Preliminary Plans Approved:
JDB
12/3/15

STRUCTURE B-40-285-27E-2

IH 94 WB/IH 43 NB OVER MENOMONEE CANAL

CONCRETE OVERLAY

TYPICAL SECTION

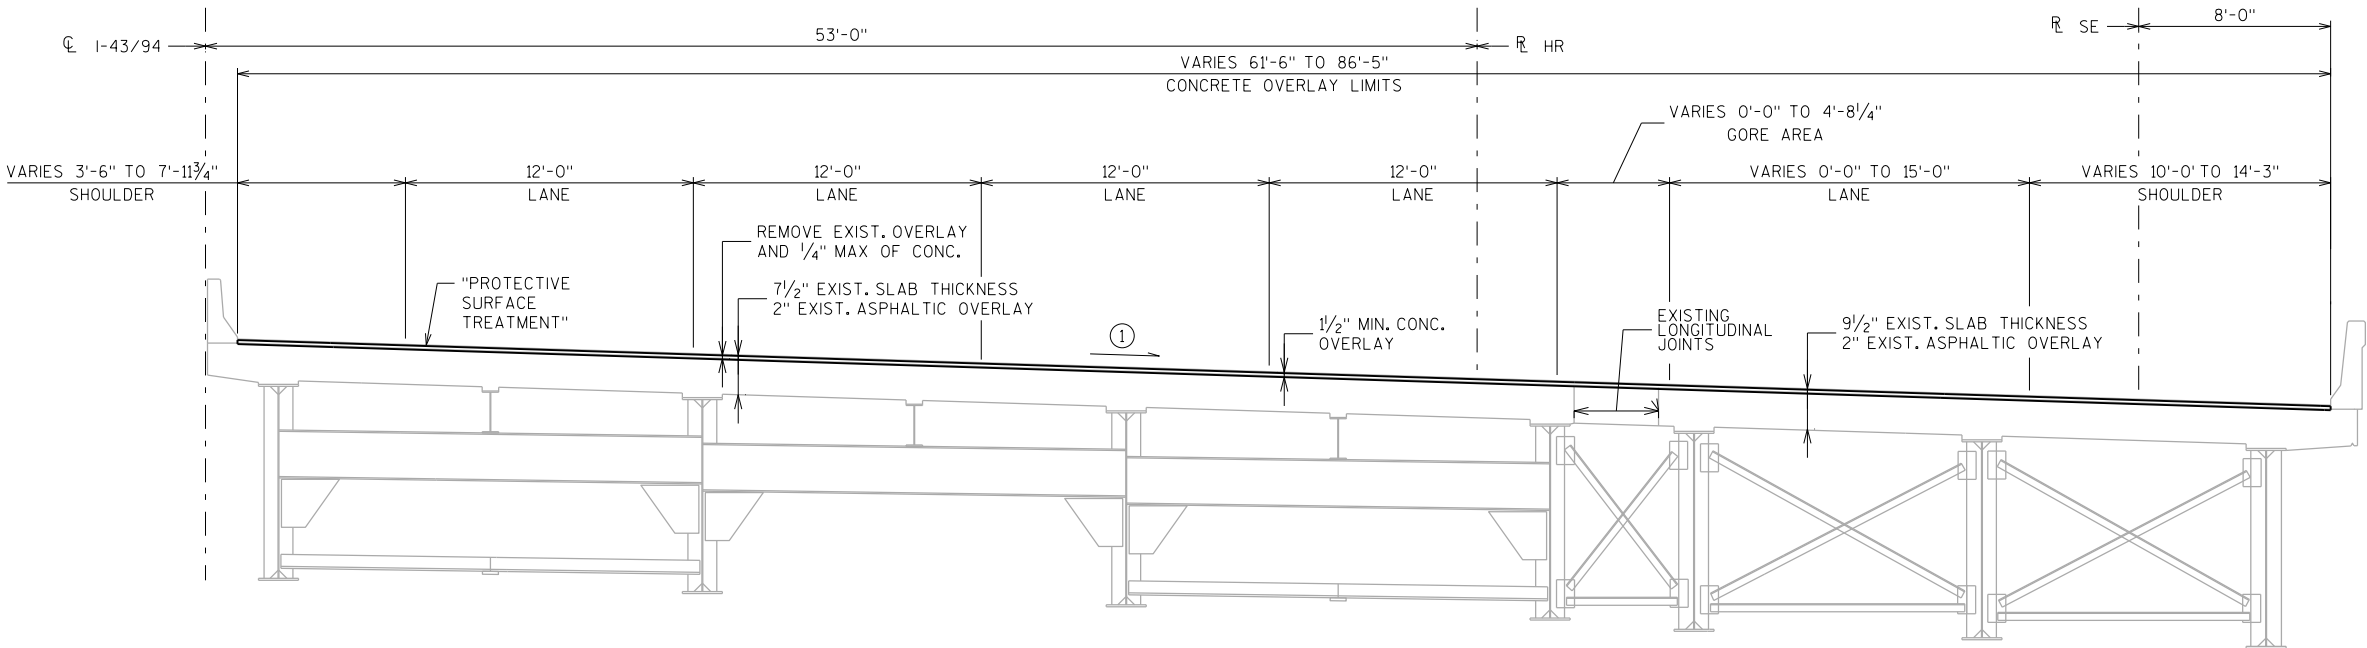
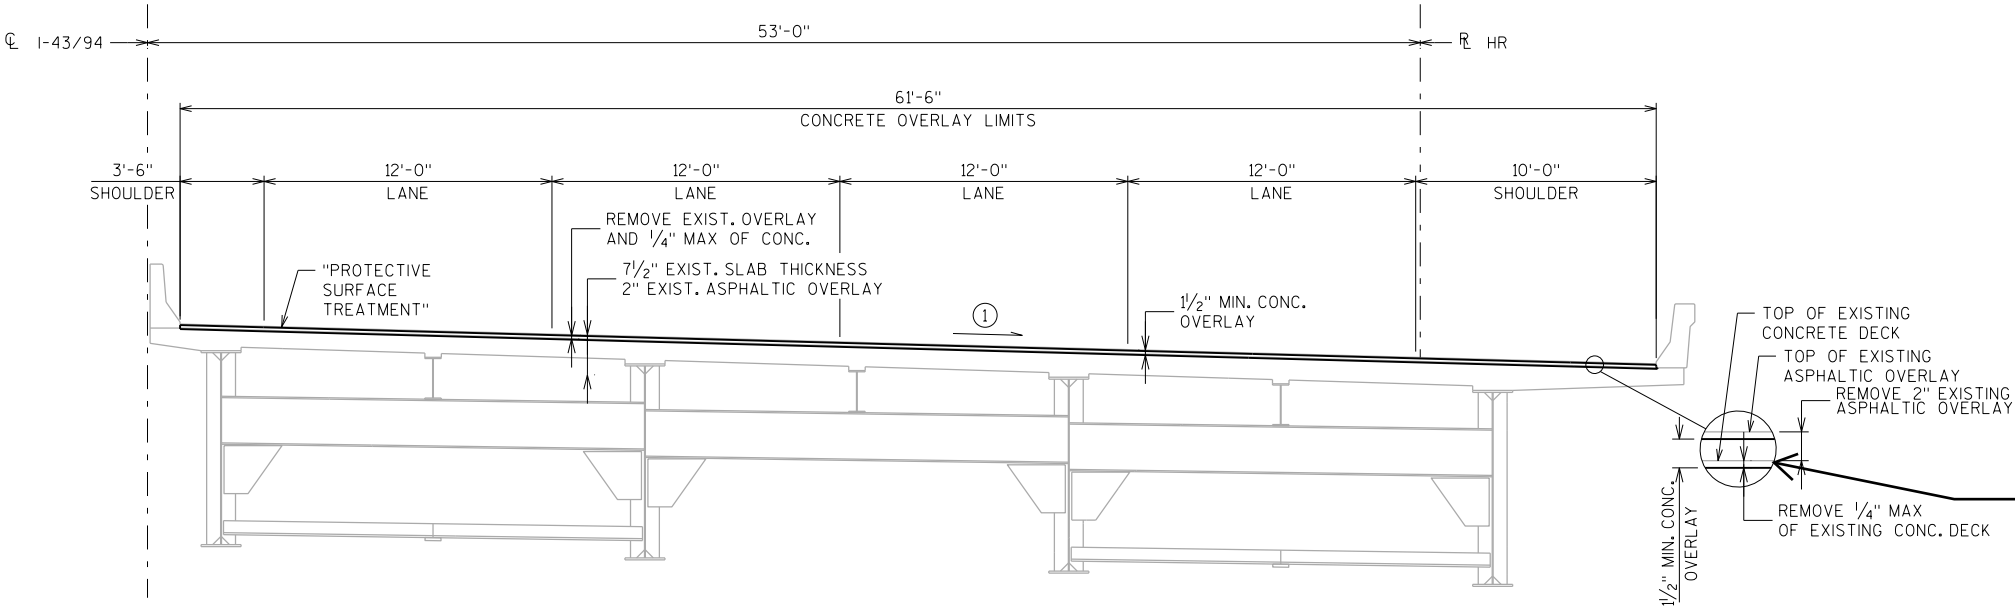
Sheet membrane waterproofing layer between asphaltic overlay and concrete deck

Include girder size / spacing on typical section drawings
